VALUE ENGINEERING REPORT

**Busbee – Frey Connector
Cobb County
CCDOT Project No. CO – 400; PI No. 0010157**

February 21, 2012

Idea No.: A-1
Client: CCDOT/GDOT
Sheet 2 of 7

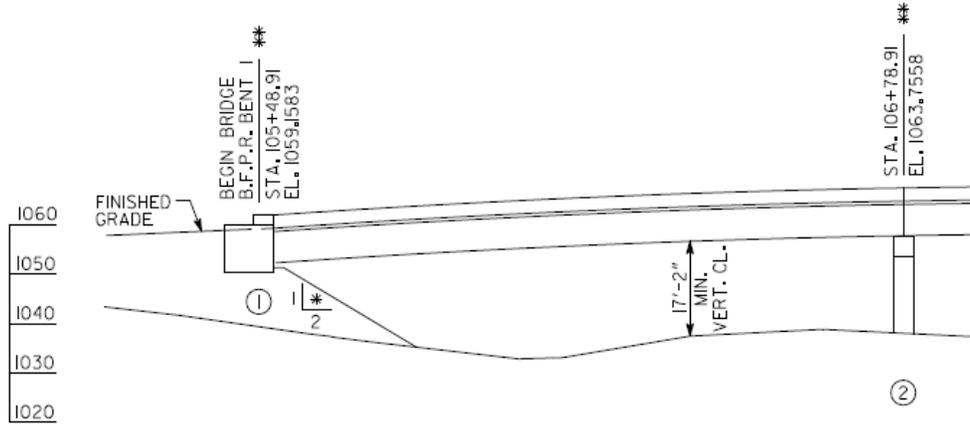
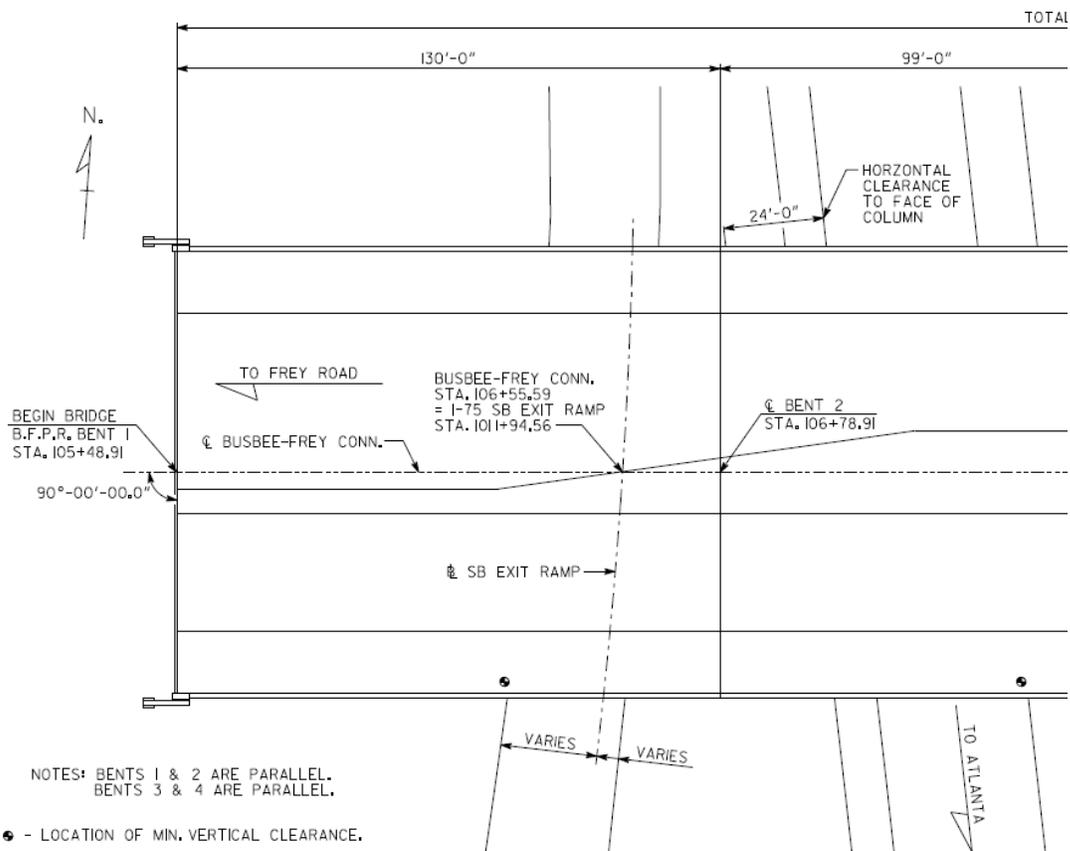
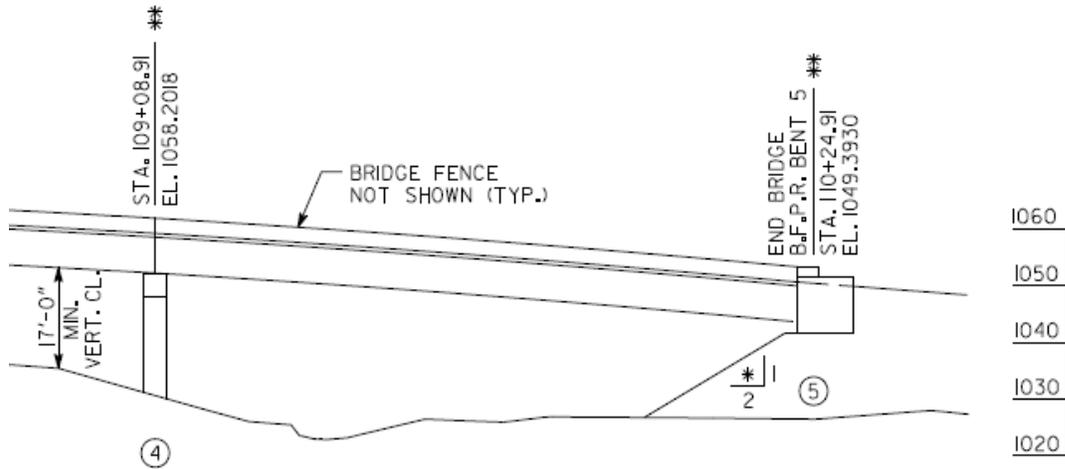
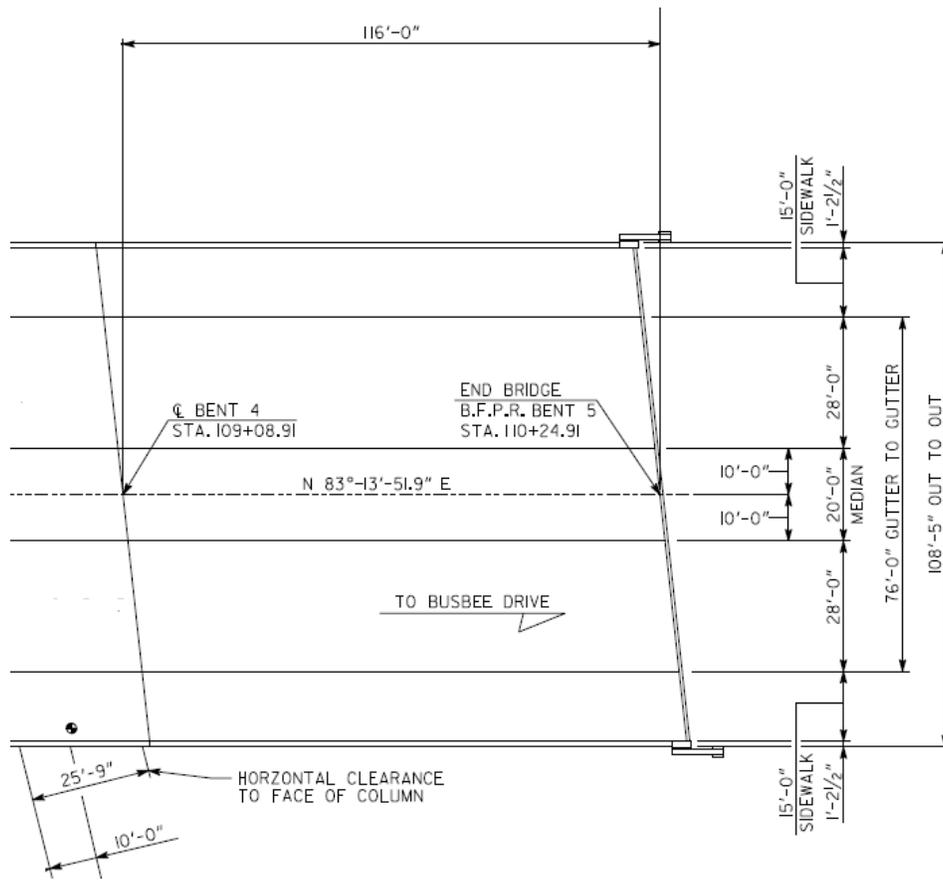
The original concept calls for a 476 ft long, four-span, PSC beam bridge carrying the Busbee-Frey Connector over I-75. The bridge spans are 130 ft, 99 ft, 131 ft and 116 ft. The bridge is supported by concrete, multi-column, intermediate bents with spill-through end bents.

Reduce the end span at Bent 1 by 39 feet (shown in the sketch). New end span = 130 feet – 39 feet = 91 feet. (39 foot reduction)

Reduce the end span at Bent 5 by 42 feet (shown in the sketch). New end span = 116 feet – 42 feet = 74 feet. (42 foot reduction)

The end spans are extensive and can be shortened while providing the same function. Shortening the end spans reduces bridge costs.

Reduce the length of the bridge end spans by moving the toe of slope closer to the edge of ramp.

Proposed Concept - PLAN VIEW @ BENT 1

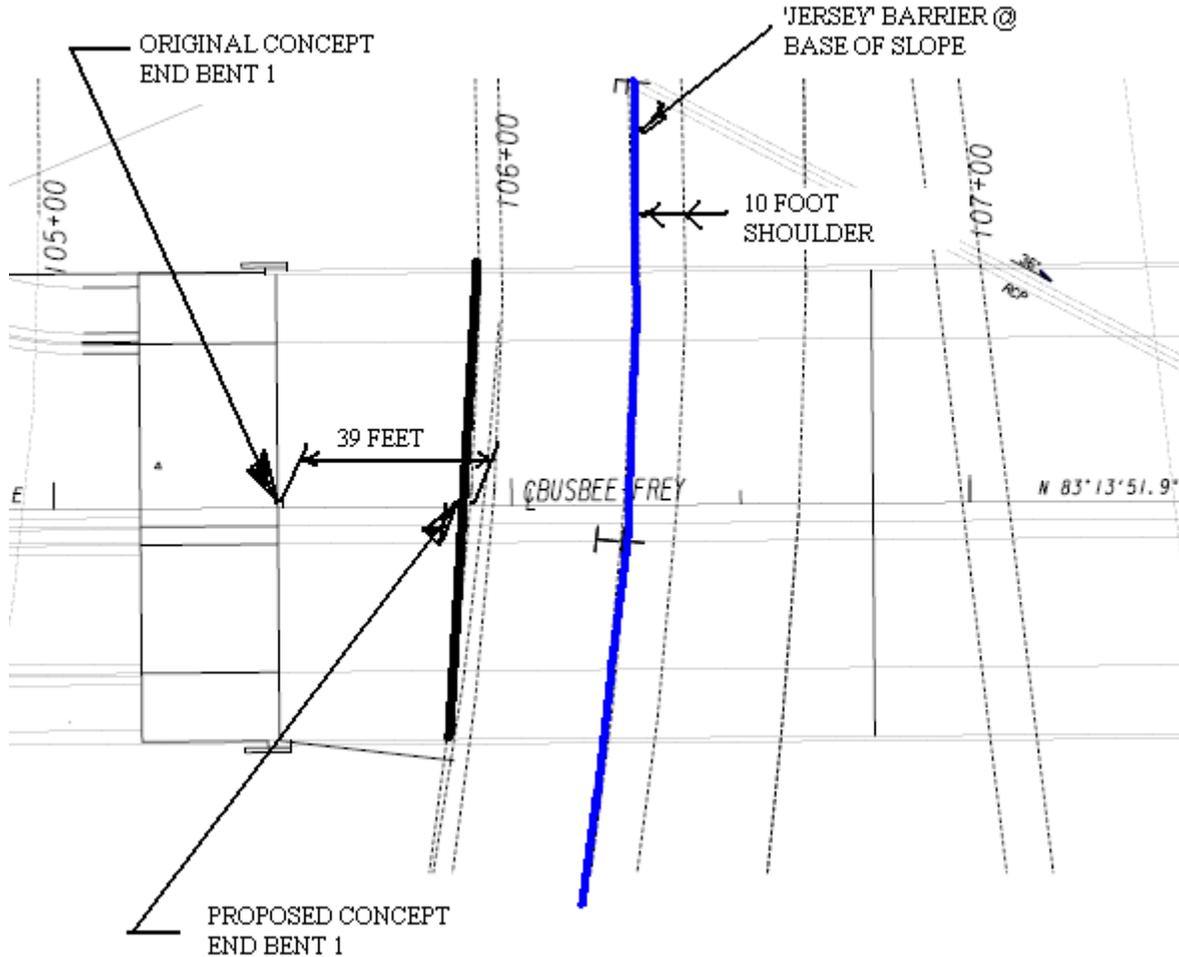
Provide barrier wall along 10 foot shoulder for ramp with leading edge guardrail to protect drivers from blunt end of guardrail (not shown in sketch). Assume 120 feet long

Proposed Concept - PLAN VIEW @ BENT 5

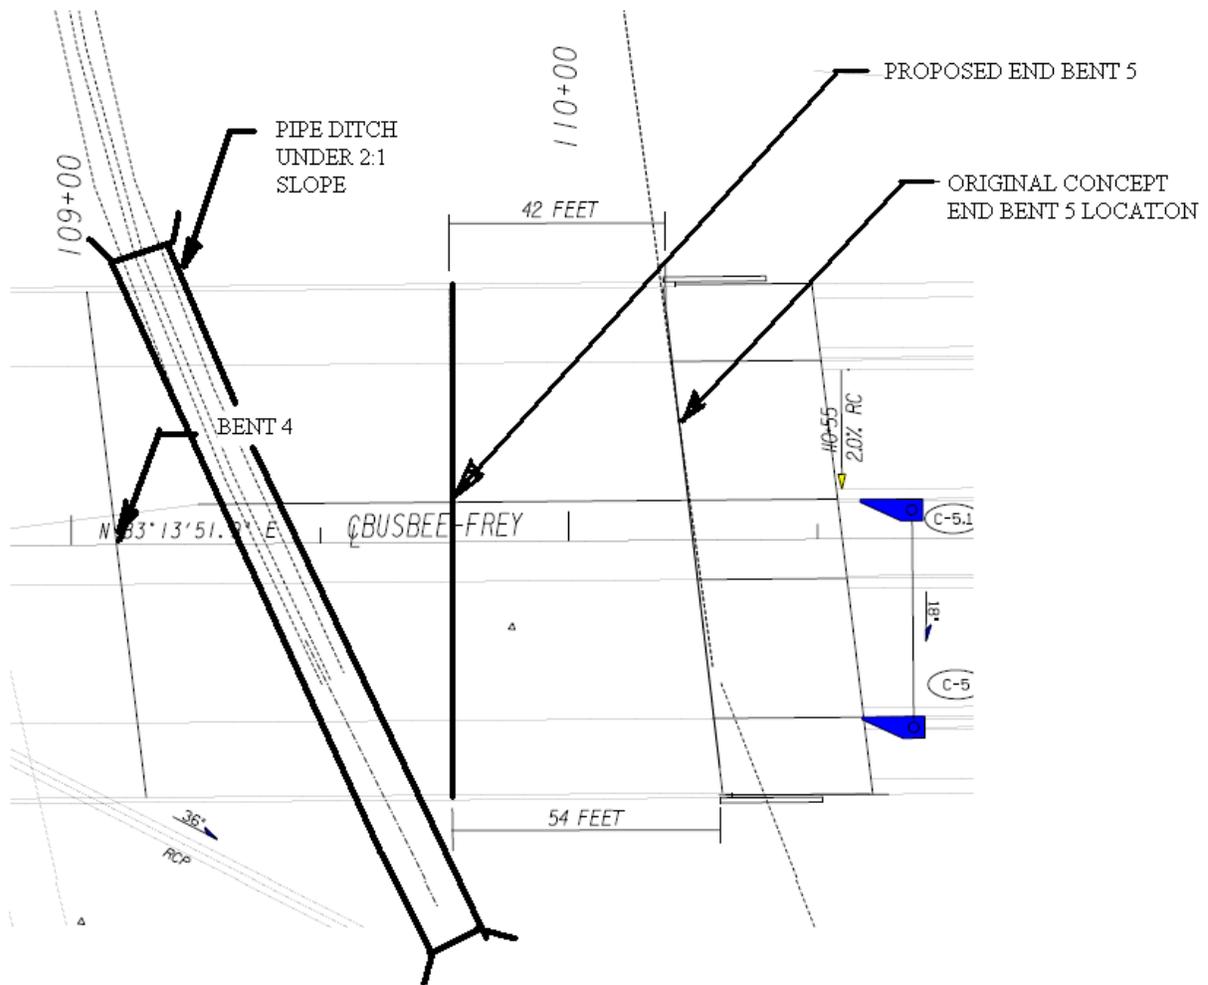
Provide a concrete pipe to carry the concrete flume through the 2:1 slope at the end of the shortened Bent 5 end span. Assume 48" pipe with 2 concrete headwalls (108 foot wide bridge + 2 side slopes of 10 feet each. Say 140 feet of pipe & 2 concrete headwalls.

Idea No.: A-3
Client: CCDOT/GDOT
Sheet 2 of 4

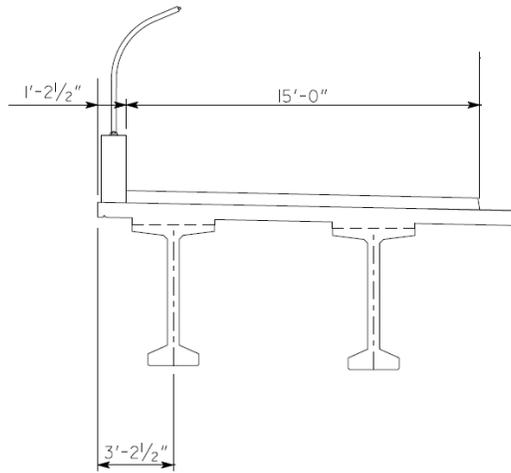
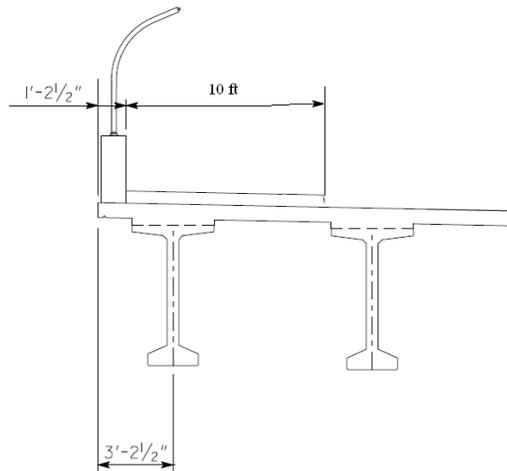
The original concept calls for a 476 ft long, four-span, PSC beam bridge carrying Busbee-Frey Connector over I-75 with 15 foot wide sidewalks. Most of the sidewalk network in the area is at 5 foot width and the proposed Busbee-Frey Connector is at 10 foot wide. The additional bridge width was included primarily for streetscape features; benches, planters, etc.

The 15 foot sidewalks are not part of a 15 foot wide sidewalk system and are proposed on the bridge only. The bridge is the most expensive component of the project per square foot. The 10 foot sidewalk width would still allow for small planters or other aesthetic items such as benches. An alternate and recommended approach is rather than spending the significantly higher bridge cost for enhanced features, create pocket parks or areas of feature immediately off of the bridge area at a significantly reduced cost.

Reduce the bridge sidewalks from 15 feet to 10 feet.

Idea No.: A-8
Client: CCDOT/GDOT
Sheet 2 of 8

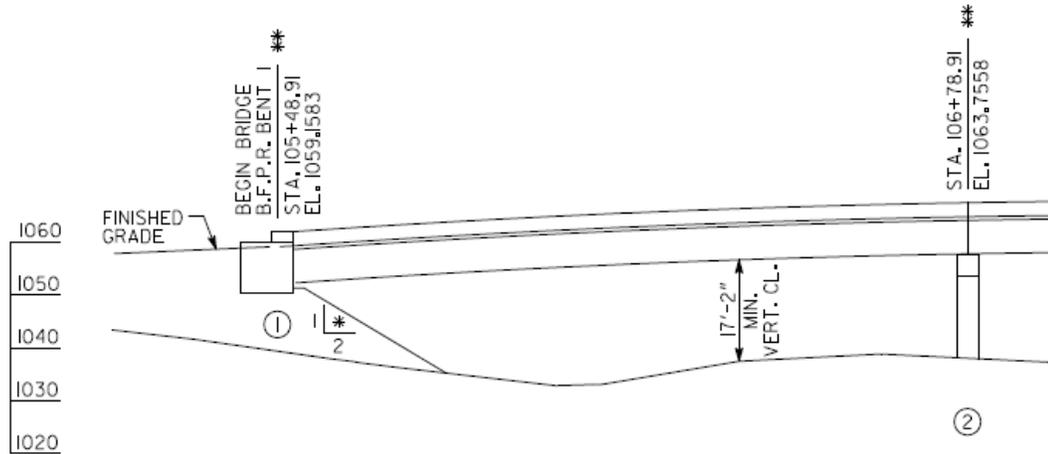
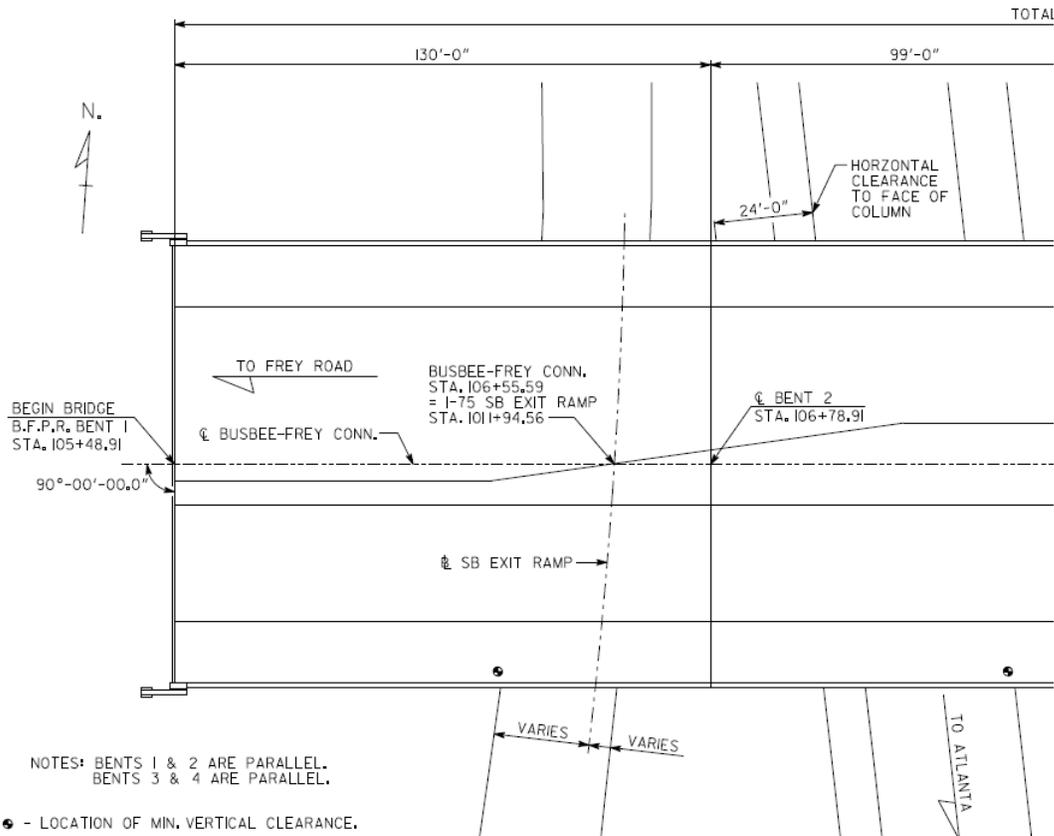
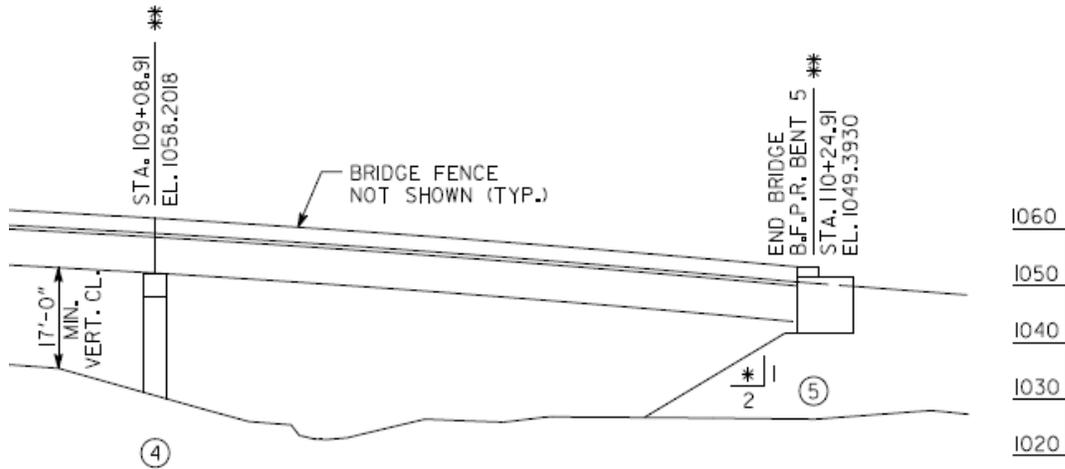
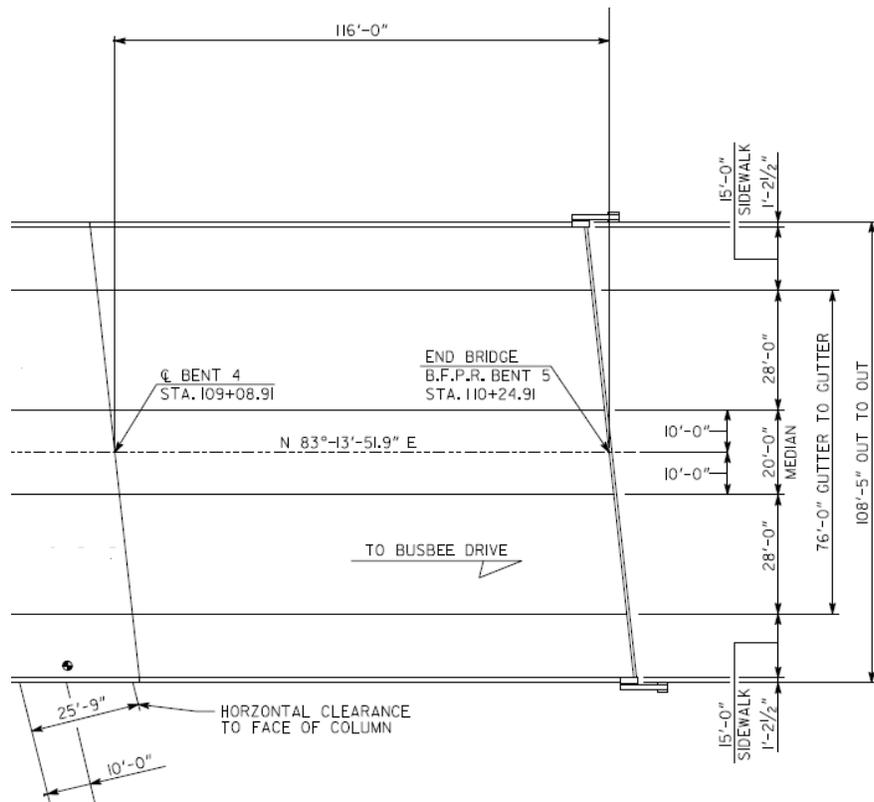
The original concept calls for a 476 ft long, four-span, PSC beam bridge carrying Busbee-Frey Connector over I-75. The bridge spans are 130 ft, 99 ft, 131 ft and 116 ft. The bridge is supported by concrete, multi-column, intermediate bents with spill-through end bents. It is assumed the bridge will be pile supported.

Reduce the end span at Bent 1 by (39 feet – 6 feet offset from face of wall to BFPR) (shown in the sketch). New end span = 130 feet – 33 feet = 97 feet. (33 foot reduction)

Reduce the end span at Bent 5 by (42 feet - 6 feet offset from face of wall to BFPR) (shown in the sketch). New end span = 116 feet – 36 feet = 80 feet. (36 foot reduction)

Constructing MSE walls in-lieu of open end spans could shorten the overall bridge length by 81 feet, if applied at both end spans. The current layout seems excessive and shorter end spans will reduce the overall project cost while providing the similar bridge function.

Reduce the length of the bridge end spans by constructing MSE walls closer to the edge of ramp.

Proposed Concept - PLAN VIEW @ BENT 1 with MSE Wall

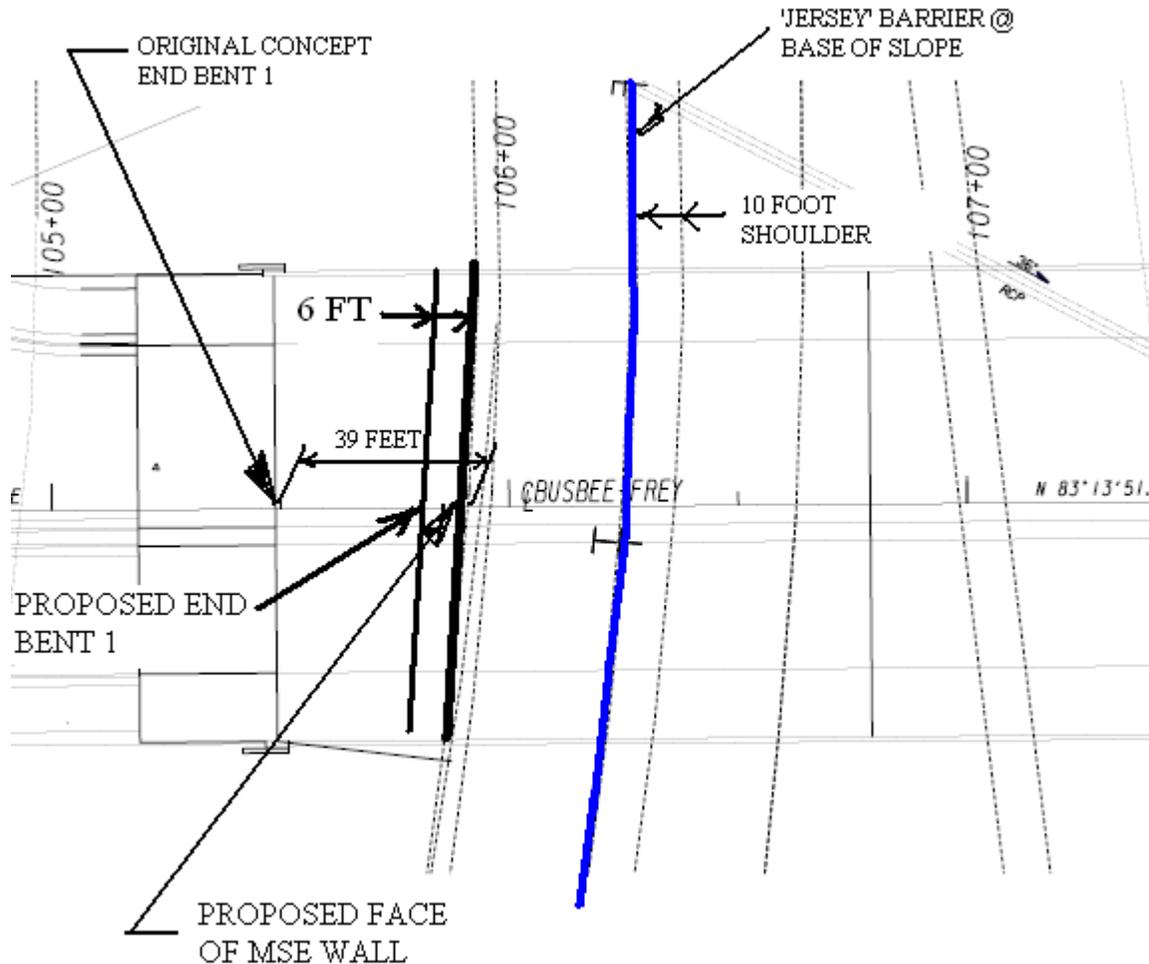
Provide barrier wall along 10 foot shoulder for ramp with leading edge guardrail to protect drivers from blunt end of guardrail (not shown in sketch). Say 120 feet long
Add Type 12 guardrail anchor with T beam guardrail.

Proposed Concept - PLAN VIEW @ BENT 5 with MSE wall

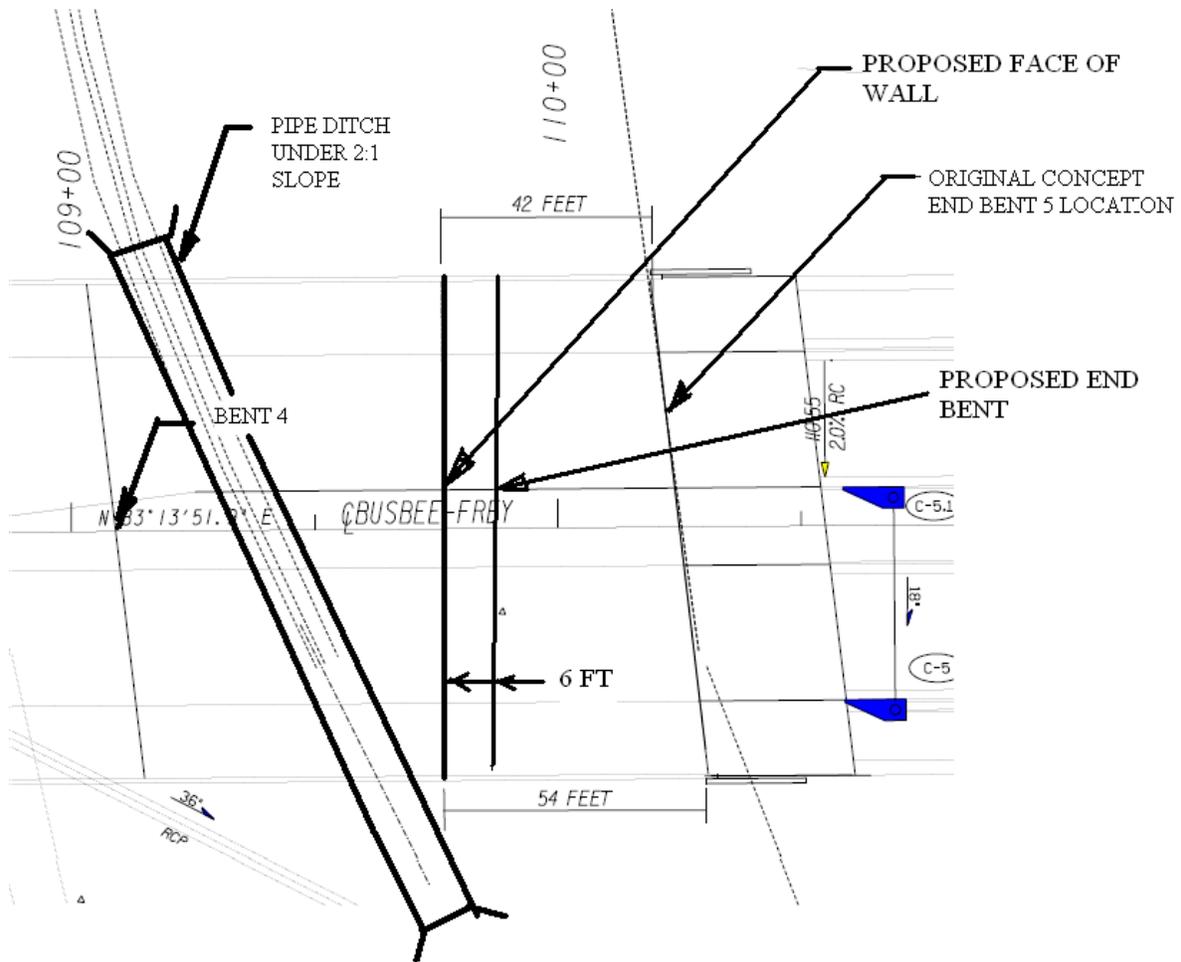
Provide a concrete pipe to carry the concrete flume through the 2:1 slope at the end of the shortened Bent 5 end span. Say 48" pipe with 2 concrete headwalls (108 foot wide bridge + 2 side slopes of 10 feet each. Say 140 feet of pipe & 2 concrete headwalls.
